PROJECT BACKGROUND - IDO ZONE DISTRICT NR-LM, WITHIN CPO-10 NORTH I-25 OVERLAY

U-HAUL

PR-2023-008710

U-Haul Moving & Storage
8200 JEFFERSON ST

SITE DATA

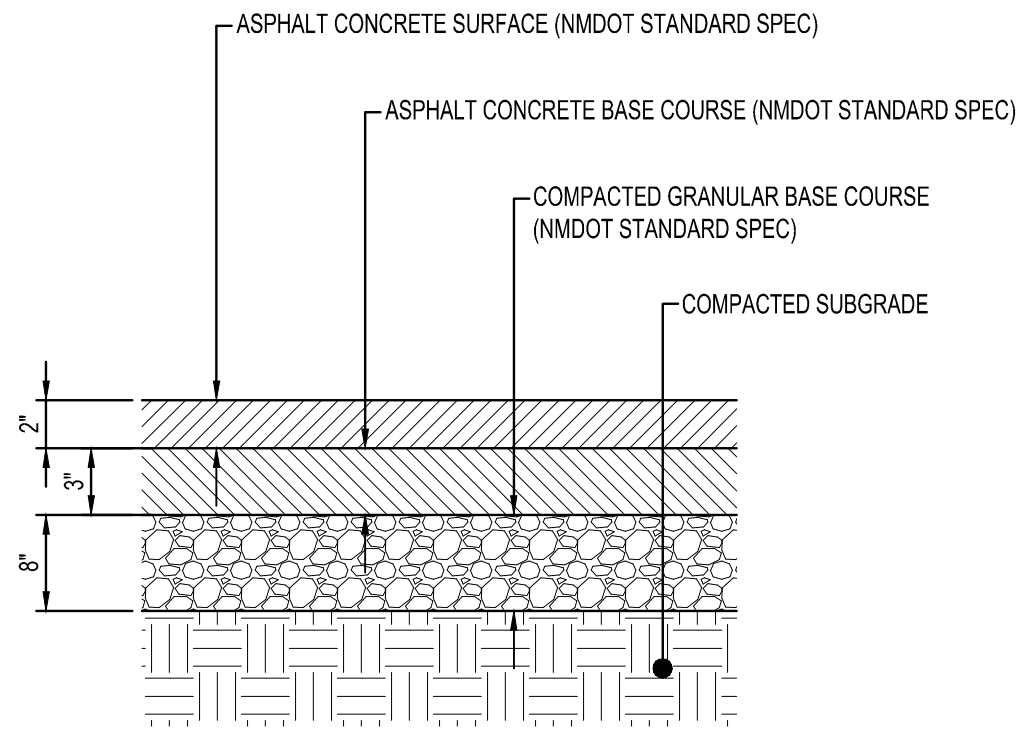
1. Clarify in detail how all Use Specific standards for Self-Storage, Light/Heavy Vehicle & Equipment sales, rental, fueling, and repair are being met. See IDO 4-3 and reference each use specific-standards and how they are met.
ISG Response: Please see the applications sections of the IDO copied below with our responses to each requirement on how the proposed site is compliant.

4-3(D)(17) Heavy Vehicle and Equipment Sales, Rental, Fueling, and Repair

- i. 4-3(D)(17)(a) This use must comply with stormwater quality requirements found in the DPM.
ISG Response: This use complies with stormwater quality requirements found in the DPM. The grading and drainage plans along with stormwater design for this project has been approved by city staff.

- ii. 4-3(D)(17)(b) The lot must be graded and surfaced pursuant to DPM standards and shall be maintained in a level and serviceable condition.
ISG Response: We have created a site grading and erosion control plan and will acquire all applicable permits needed and grad the site to development standards.

- iii. 4-3(D)(17)(c) This use must be screened as required by Subsection 14-16-5- 6(G)(4) (Outdoor Storage Areas for Vehicles, Equipment, and Materials). The Planning Director may require a taller wall, fence, or vegetative screen to provide an adequate buffer for an abutting Residential zone district or lot containing a residential use in any Mixed-use zone district from the reasonably anticipated visual or noise impacts of this use.
ISG Response: Not applicable as no adjacent site contains a residential use.

- iv. 4-3(D)(17)(d) For fueling station canopies, all under-canopy lighting shall be recessed so that no light lens projects below the canopy ceiling. The canopy fascia shall not be internally illuminated.
ISG Response: No fueling station canopies are proposed on this project.

- v. 4-3(D)(17)(e) Vehicle repair, servicing, and maintenance shall be conducted within fully enclosed portions of a building.
ISG Response: No vehicle repair, servicing or maintenance are proposed as a use on this project.

- vi. 4-3(D)(17)(f) Any building that contains vehicle repair, servicing, and maintenance is prohibited within 25 feet in any direction of any Residential zone district or lot containing a residential use in any Mixed-use zone district.
ISG Response: This site is over 25-ft of any residential use in any direction.

- vii. 4-3(D)(17)(g) If located within 330 feet of any Residential zone district, this use shall require a Conditional Use Approval pursuant to Subsections 14-16-5-2(E) and 14-16-6-6(A).
ISG Response: This is not applicable as the closest residential property is a little over 500-ft away from the closest edge of the subject site.

- viii. 4-3(D)(17)(h) This use is prohibited within 330 feet in any direction of Major Public Open Space.
ISG Response: Not applicable as the site is not within 330-ft of any major public open space.

- ix. 4-3(D)(17)(i) A cumulative impacts analysis may be required at the time of application submittal for projects within the Railroad and Spur Small Area, pursuant to Subsections 14-16-5-2(E) (Cumulative Impacts) and 14-16-6-4(H) (Cumulative Impacts Analysis Requirements).
ISG Response: Not applicable as the site is not within this area.
